#### APPEAL SUMMARY

<b>Appeal ID:</b> 24409	<b>Project Address:</b> 1111 SE Tenino St
<b>Hearing Date:</b> 11/25/20	<b>Appellant Name:</b> Edward Radulescu
<b>Case No.:</b> B-014	<b>Appellant Phone:</b> 5036792493
<b>Appeal Type:</b> Building	<b>Plans Examiner/Inspector:</b> Sloan Shelton
<b>Project Type:</b> commercial	<b>Stories:</b> 3 <b>Occupancy:</b> R-2 <b>Construction Type:</b> V-B
<b>Building/Business Name:</b> SE 11th Apartments 1	<b>Fire Sprinklers:</b> Yes - NFPA 13R Throughout
<b>Appeal Involves:</b> Erection of a new structure	<b>LUR or Permit Application No.:</b> 19-265965-CO
<b>Plan Submitted Option:</b> mail [File 1] [File 2] [File 3] [File 4]	<b>Proposed use:</b> R-2 Apartments

11TH AVE  
19-UNIT APARTMENT HOUSE  
8134 SE 11TH AVE  
PORTLAND, OREGON  
EPR DESIGN

A3.1

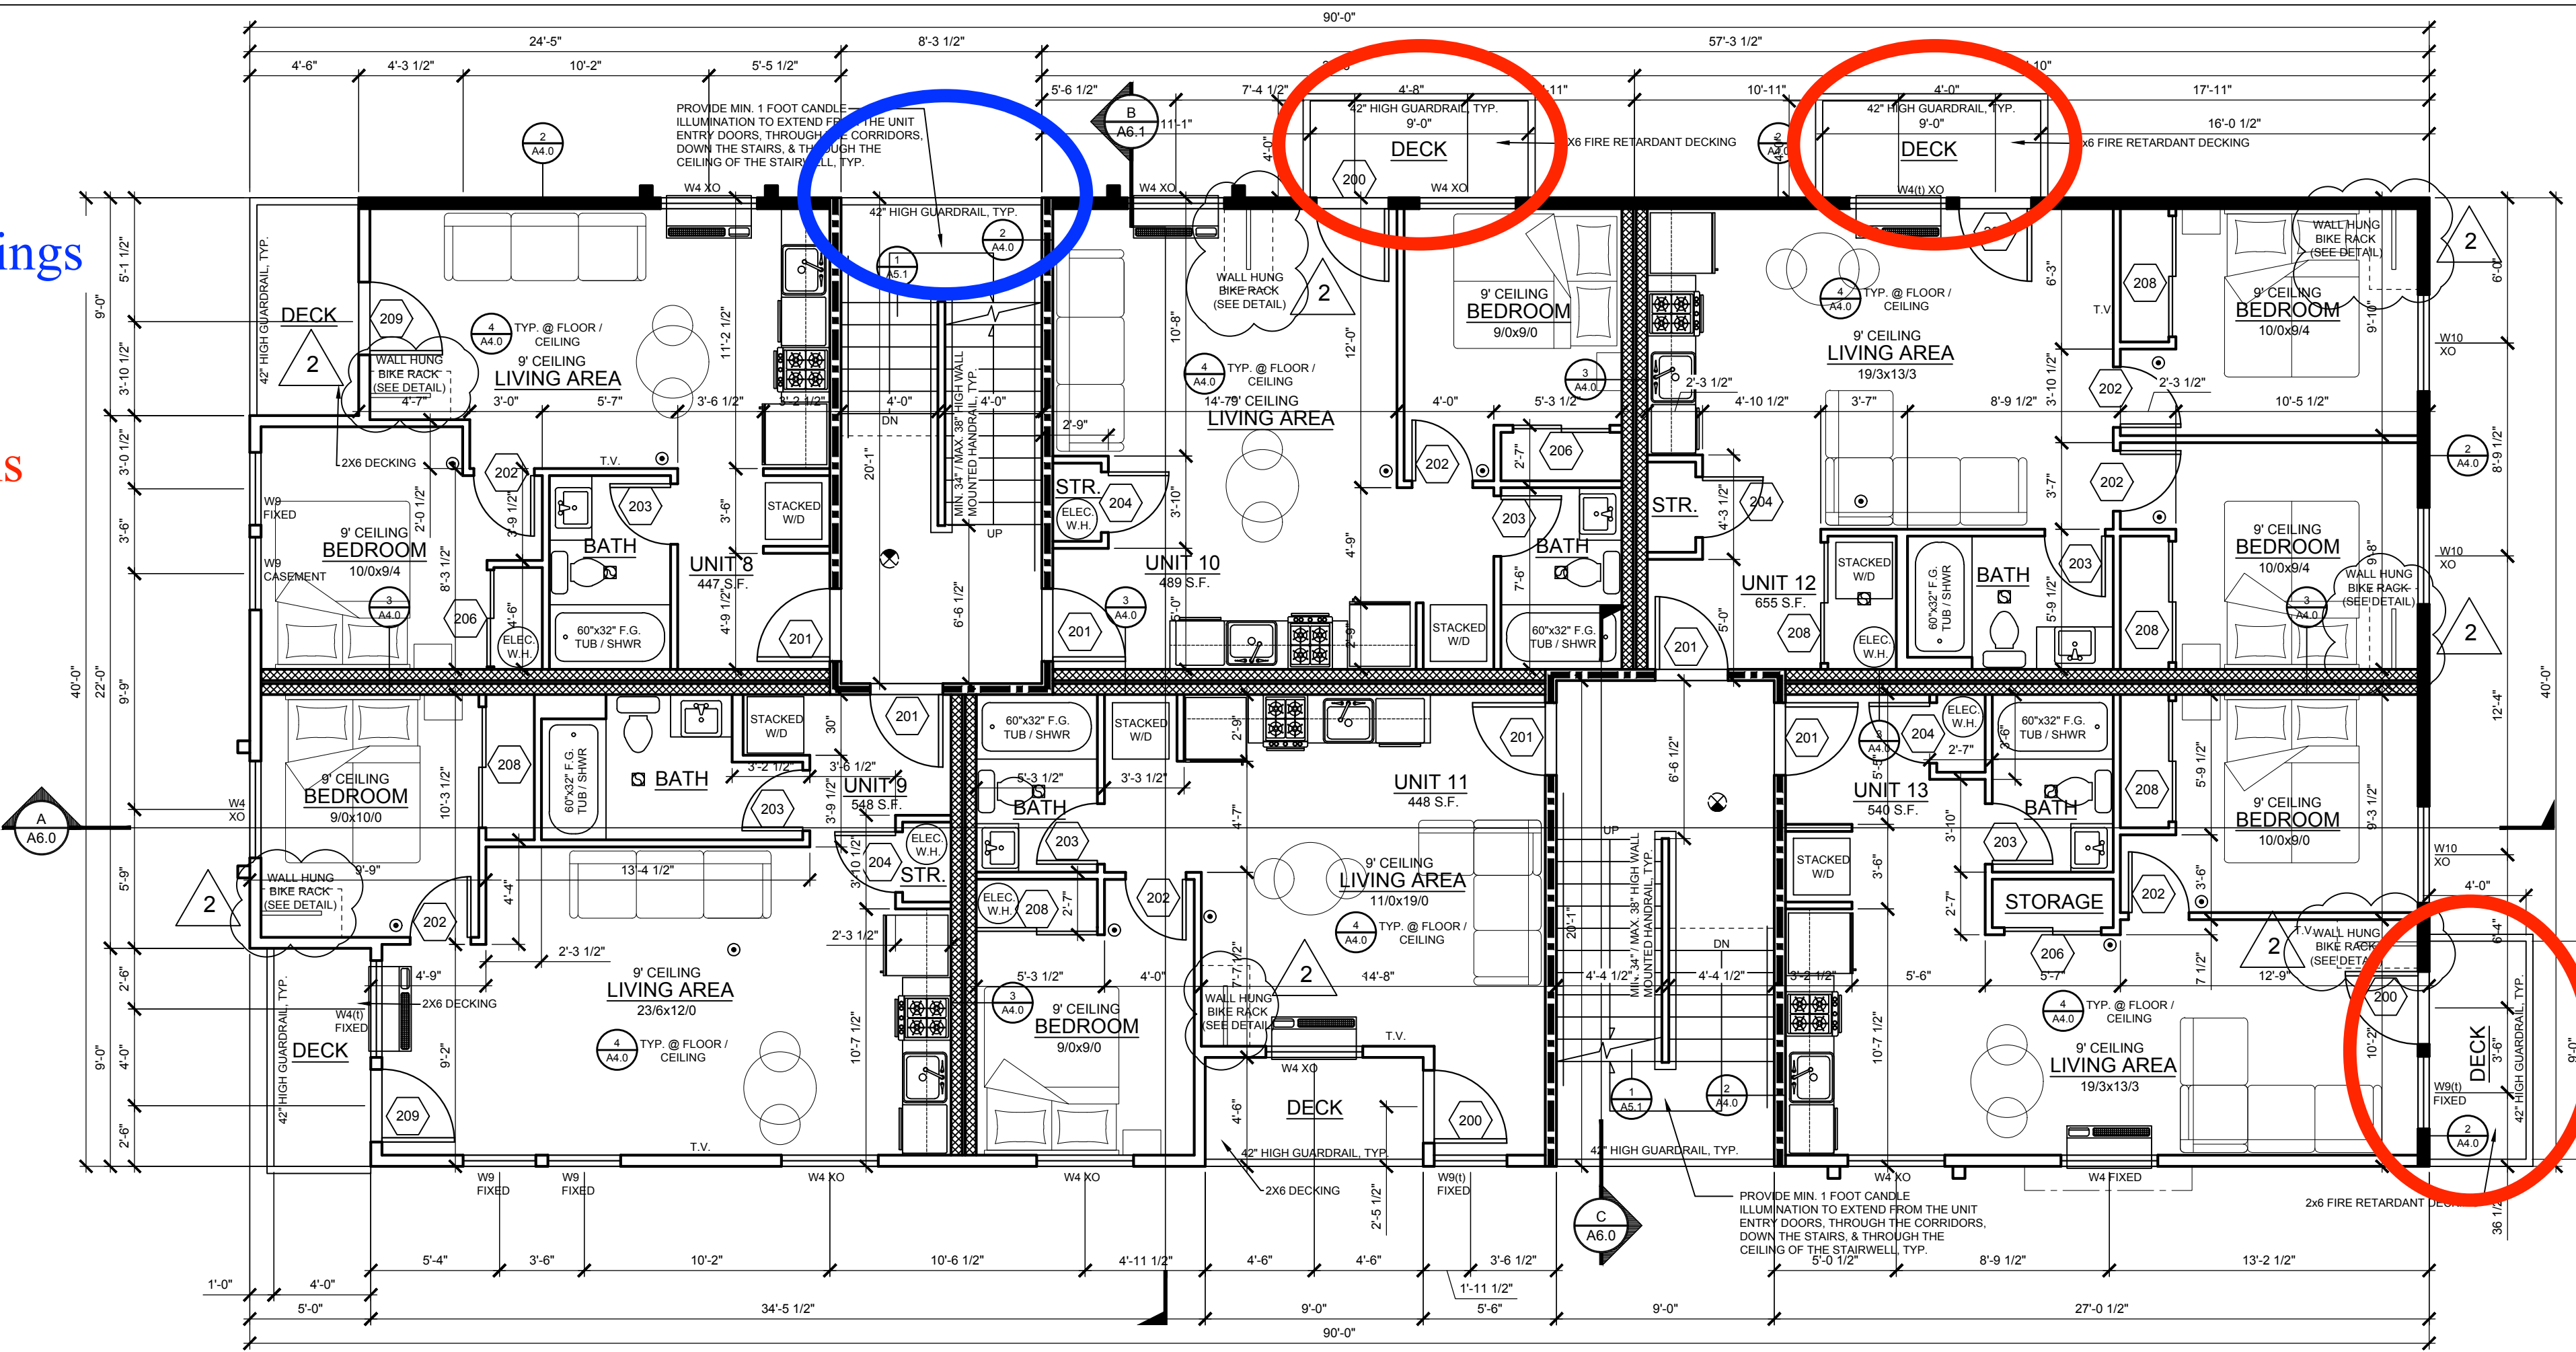
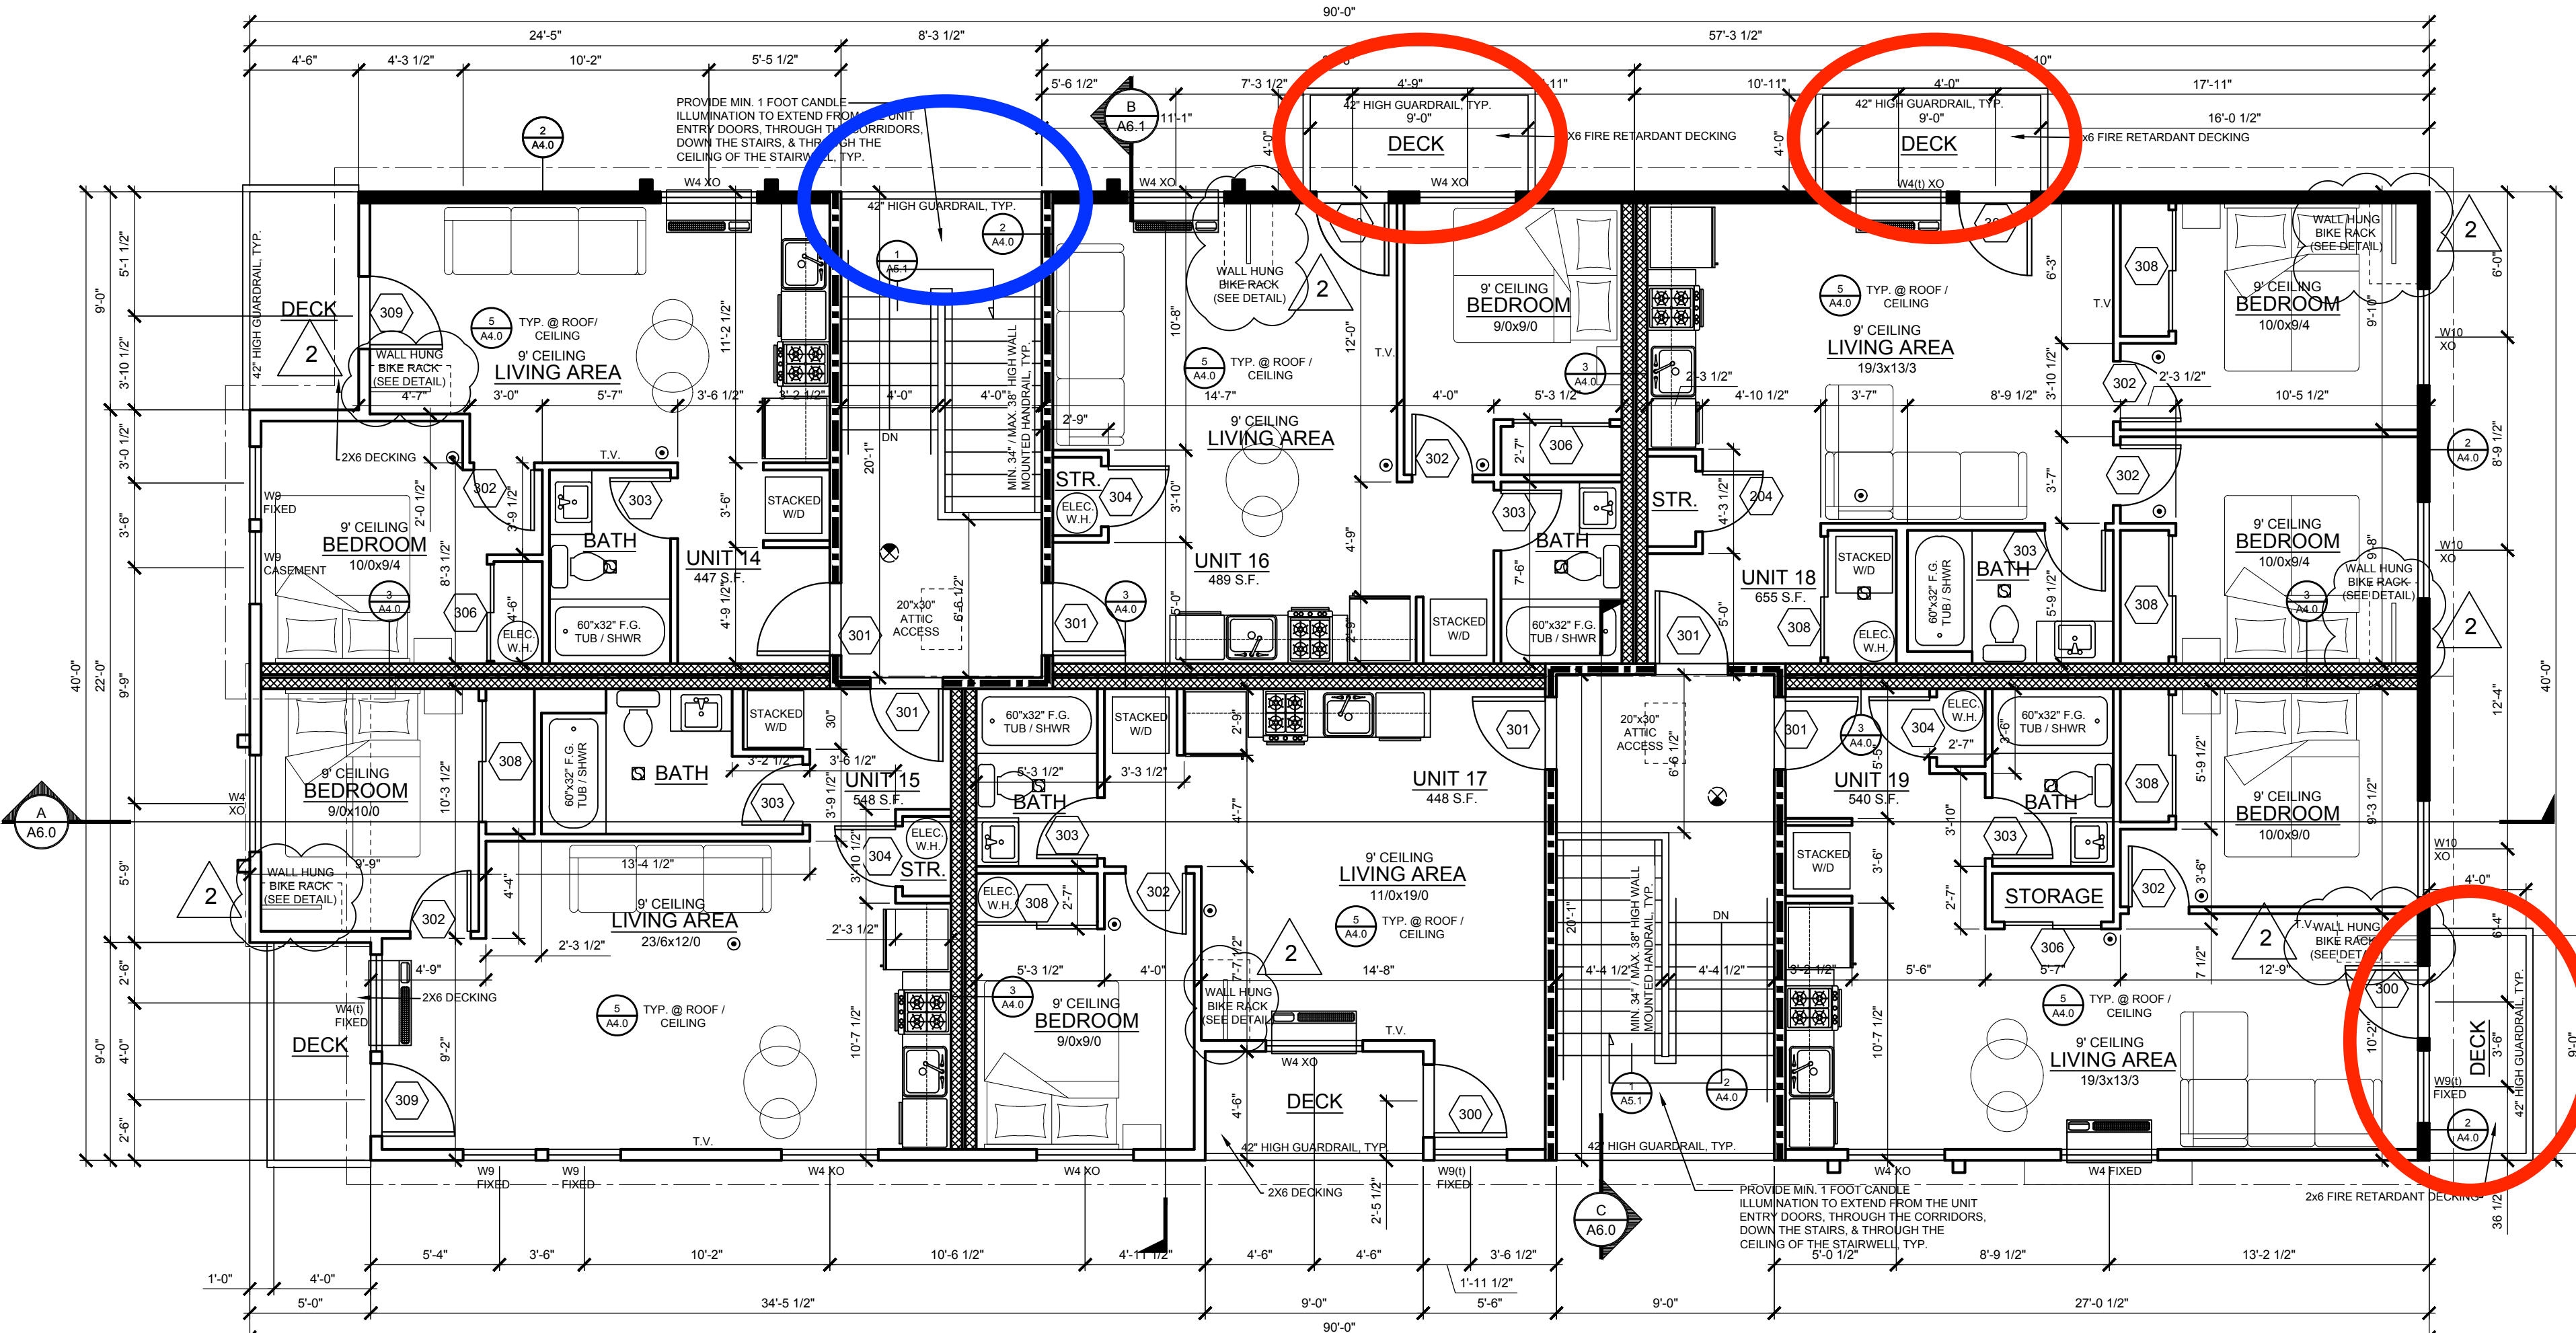
<b>Code Section</b>	705.2
<b>Requires</b>	Cornices, eave overhangs, exterior balconies and similar projections extending beyond the exterior wall shall conform to the requirements of this section and Section 1406. Exterior egress balconies and exterior exit stairways and ramps shall also comply with Sections 1019 and 1026, respectively. Projections shall not extend any closer to the line used to determine the fire separation distance than shown in Table 705.2.
<b>Code Modification or Alternate Requested</b>	Applicant wishes to upgrade the sprinkler system to a full NFPA 13, construct the balconies of fire retardant treated wood, and provide sprinkler heads at the balconies in order to allow for a greater projection.
<b>Proposed Design</b>	This appeal applies to the 4 balconies on the north side and the 2 on the east side of the proposed building - on the north side; 2 at the 2nd floor and 2 at 3rd floor and on the east side 1 on the 2nd floor and 1 on the 3rd floor. The balconies are stacked. The exterior walls of the building are one hour construction, the balcony guardrails are of non-combustible materials, and the deck will be constructed of fire retardant treated wood and heavy timbers for 1-hour construction. The sprinkler system in the building will be upgraded from NFPA 13R to NFPA 13 and sprinkler heads will be provided at each balcony per the Fire Curtain requirements.

<b>Code Section</b>	705.8, 1027.5
<b>Requires</b>	Openings in exterior walls shall comply with Section 705.8.1 through 705.8.6.2. Table 705.8 allows for openings in a wall with a fire separation distance of 5' to less than 10' and where the openings are unprotected but the building is sprinklered to have 25% openings. 1027.5 requires landings at exterior exit stairs to have a fire separation distance of 10'.
<b>Code Modification or Alternate Requested</b>	The applicant wishes to not have the opening at the exterior stairs be included in the exterior wall opening area calculation and allow the landings to be at a fire separation distance of 5' from the property line.
<b>Proposed Design</b>	The exterior stair on the north side is open on 1 side and has a fire separation distance of 5' at the opening and stair landings from the property line. A water curtain will be proposed at the stair landings on each floor and at the ceiling on the 3rd floor per 705.8.2 in lieu of enclosing the stairs and allowing it to be excluded from the fire separation distance opening area calculation. The exterior walls of the building, including the exterior walls that wrap around the stairs are constructed as 1-hour rated exterior wall assemblies. The exception in 705.8.2 states "Opening protectives are not required where the building is equipped with an automatic sprinkler system in accordance to 903.1.1.1 and the exterior openings are protected by a water curtain using automatic sprinklers approved for that use." The applicant wishes to have this exception apply to the exterior wall opening created by the exterior exit stair.

**1. Decrease in maximum allowable fire separation distance of balcony projection: Hold for additional information.**

**2. Increase in allowable area of exterior wall openings with sprinkler protection: Hold for additional information.**
